ADDENDUM NO. 1

May 10, 2022

Silver Creek School District – Athletics Package and Steel & Roofing Package
Sellersburg, IN 47172

1 SECOND FLOOR & LOW ROOF FRAMING PLAN - UNIT B
SCALE: 1/8" = 1'-0"

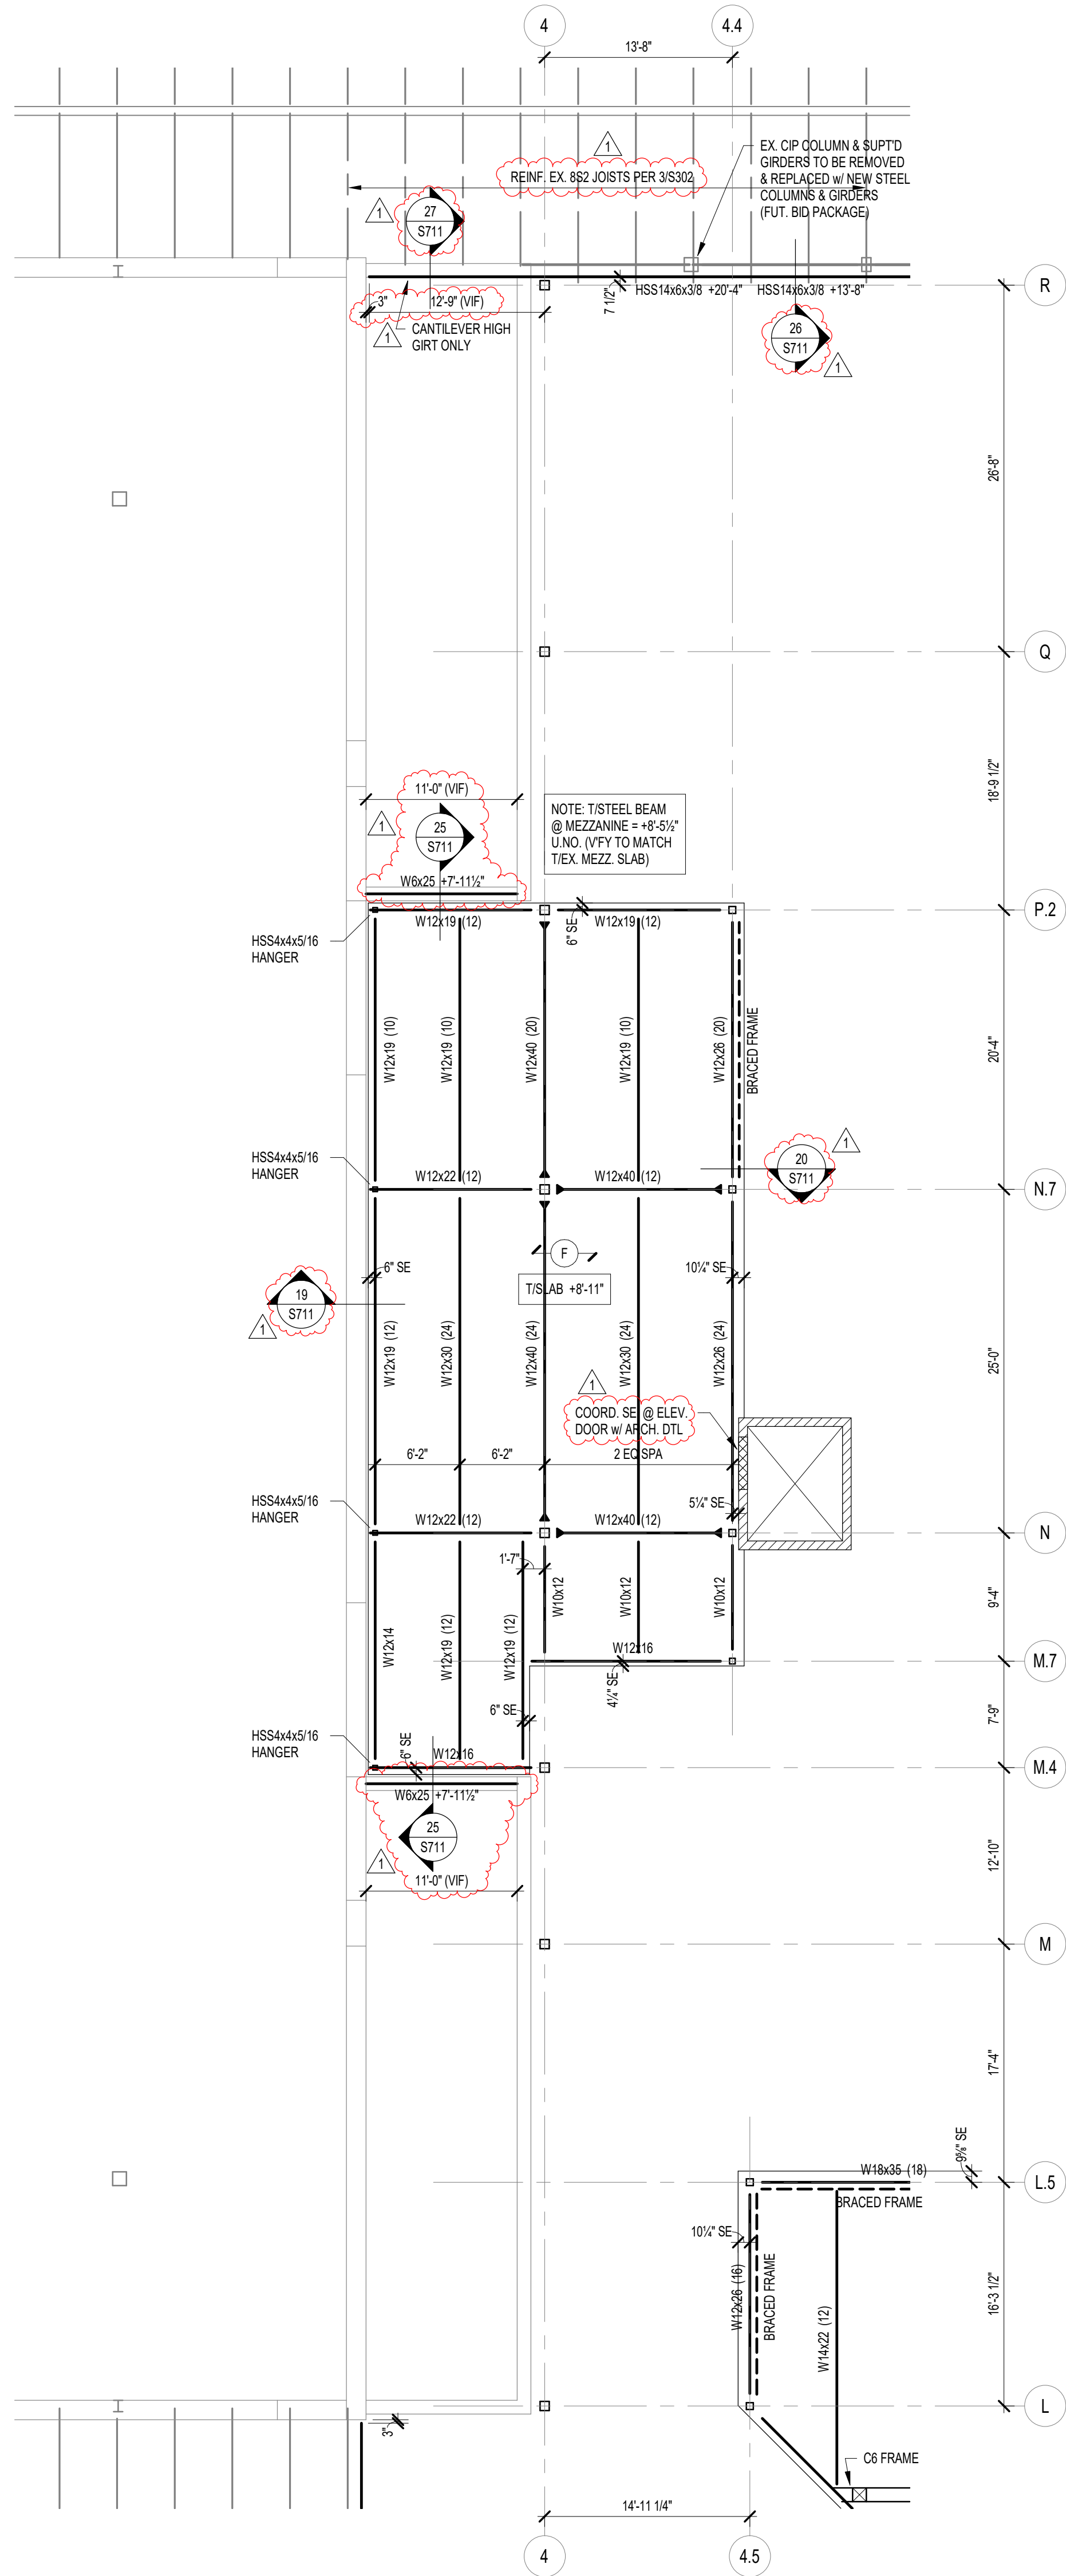
3.4 ☐ S202B – SECOND FLOOR & LOW ROOF FRAMING PLAN – UNIT B

- ☐ Add section cut references as shown on attached revised sheet.
- ☐ Add girt cantilever dimensions as shown on attached revised sheet.
- ☐ Add existing joist reinforcing note as shown on attached revised sheet.
- D ☐ Add slab edge note at elevator door as shown on attached revised sheet.
- ☐ Add W6x25 support beams below new openings in existing concrete walls as shown on attached revised sheet.

DRAWING TITLE:
SECOND FLOOR
& LOW ROOF
FRAMING PLAN -
UNIT E

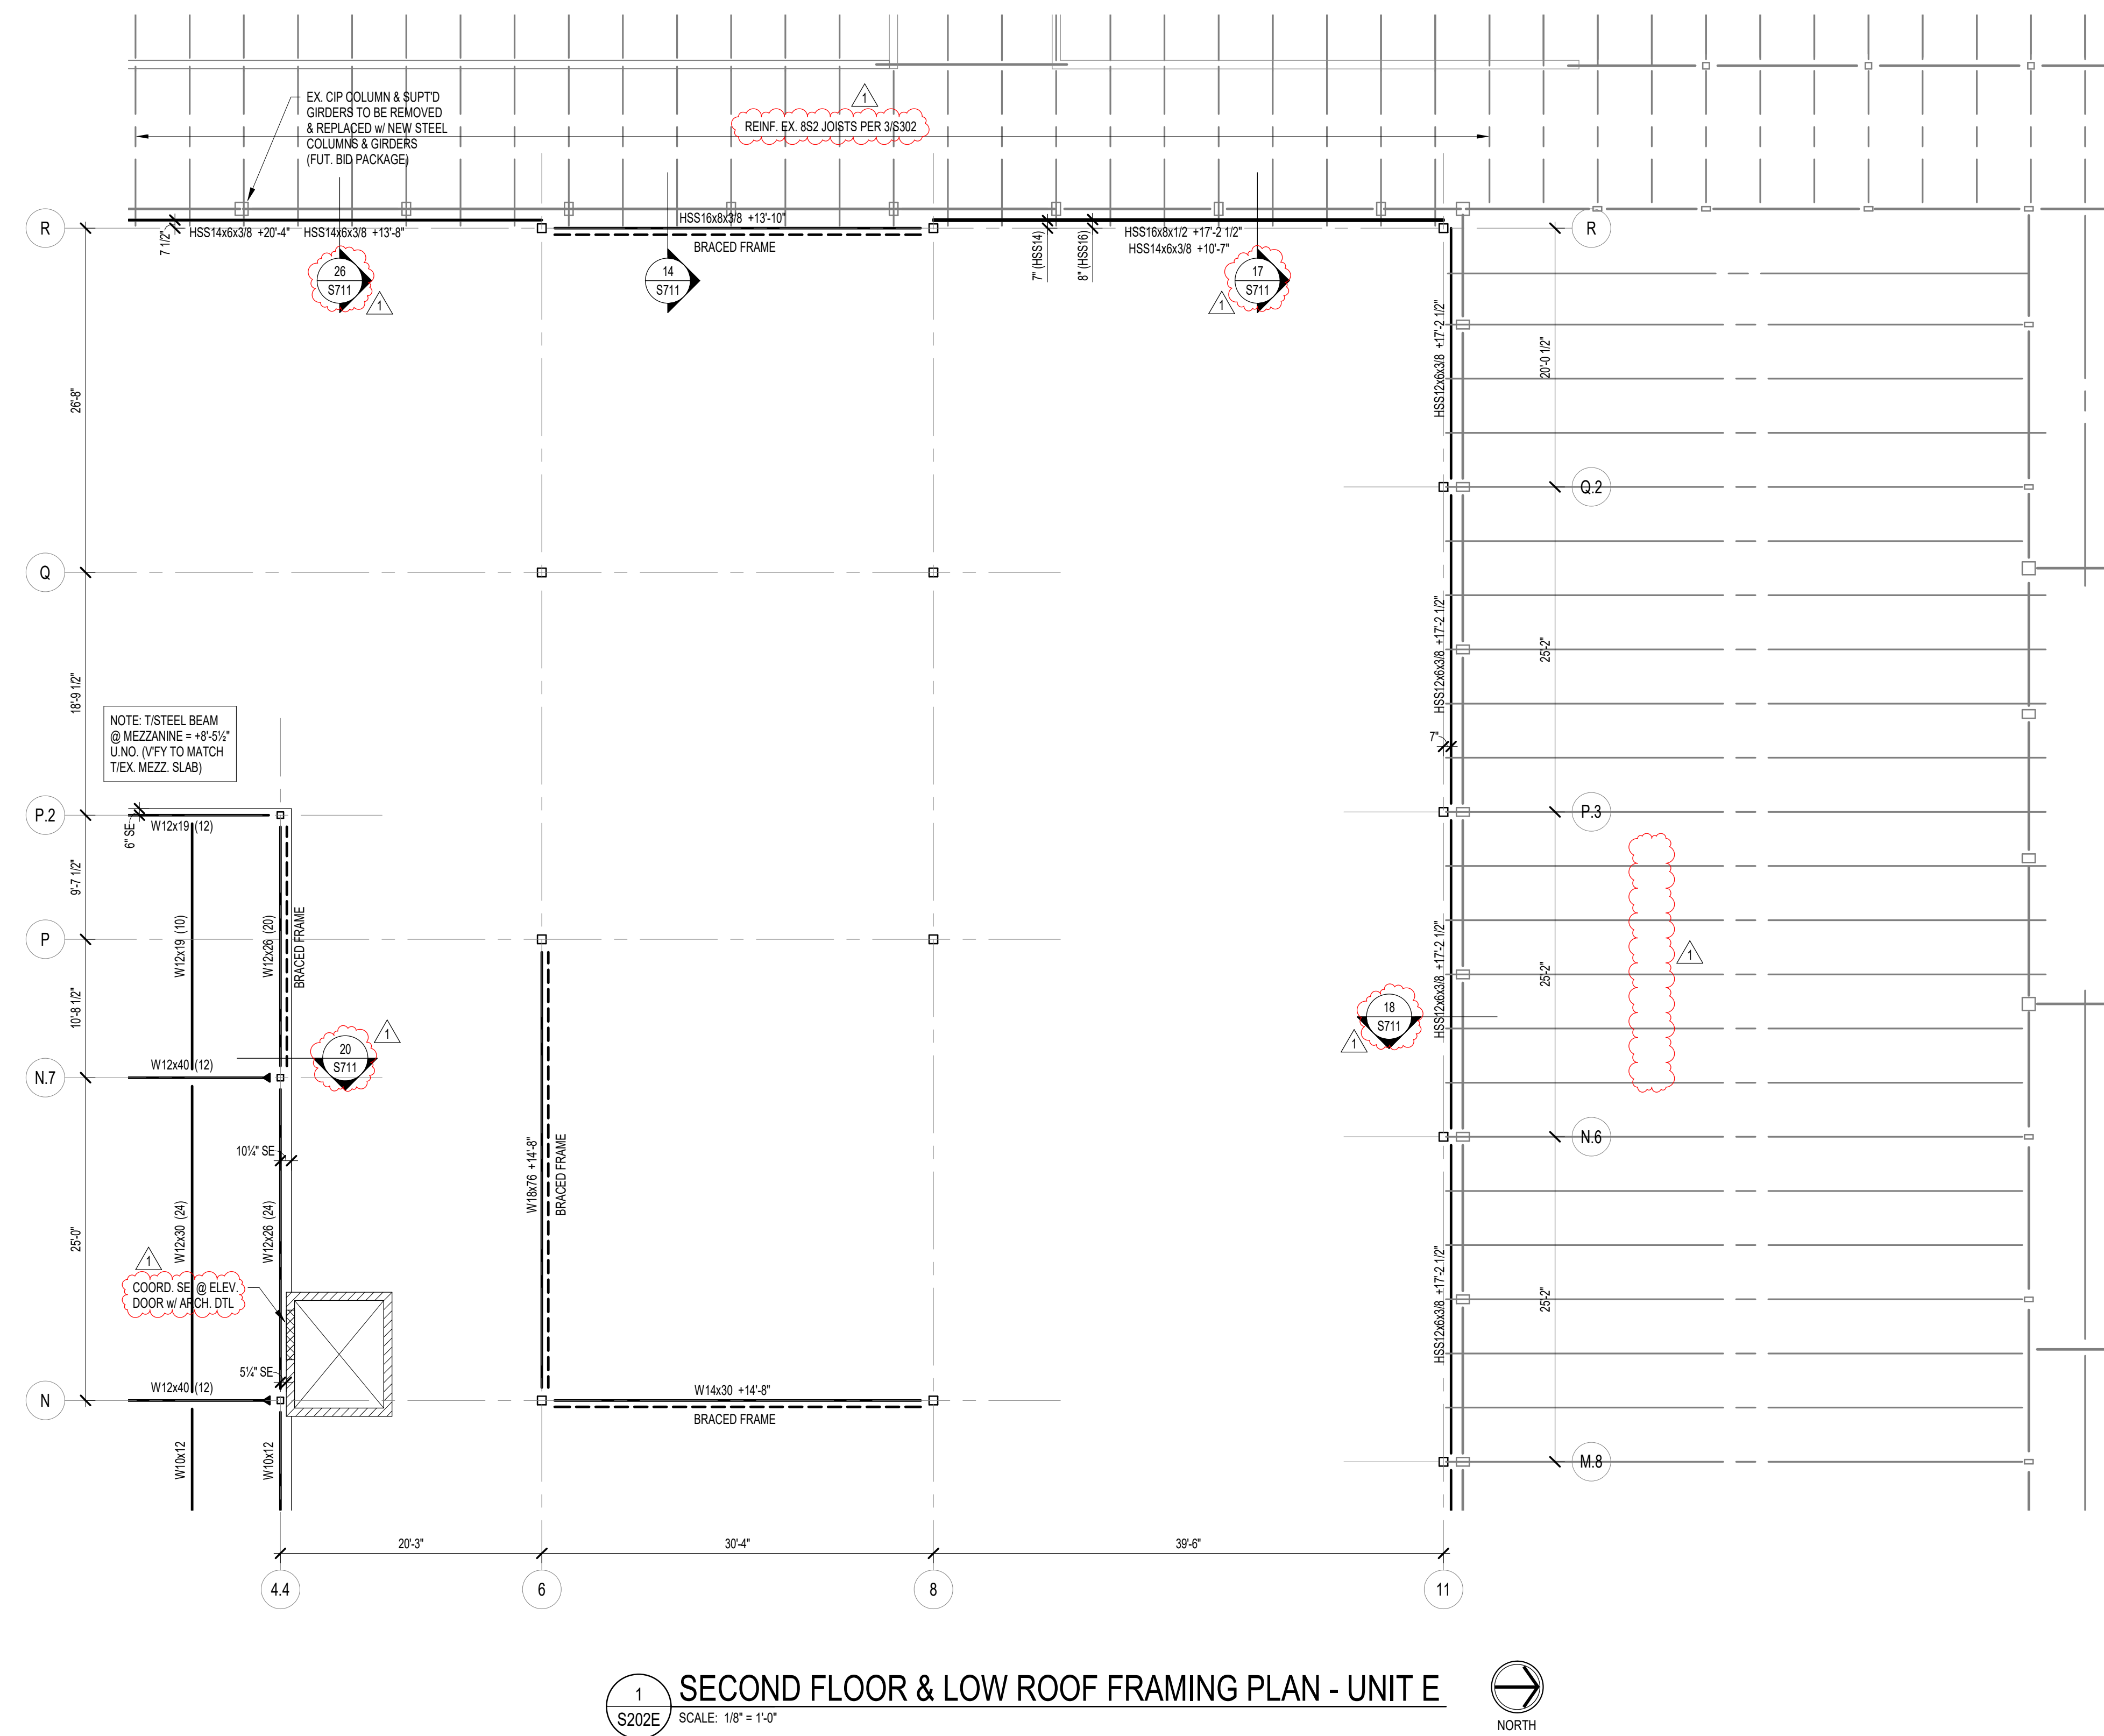
3.6 ☐ S202E – SECOND FLOOR & LOW ROOF FRAMING PLAN – UNIT E

- ☐ Add section cut references as shown on attached revised sheet.
- ☐ Delete previous existing joist reinforcing notation and add revised joist reinforcing note.
- ☐ Add slab edge note at elevator door as shown on attached revised sheet.
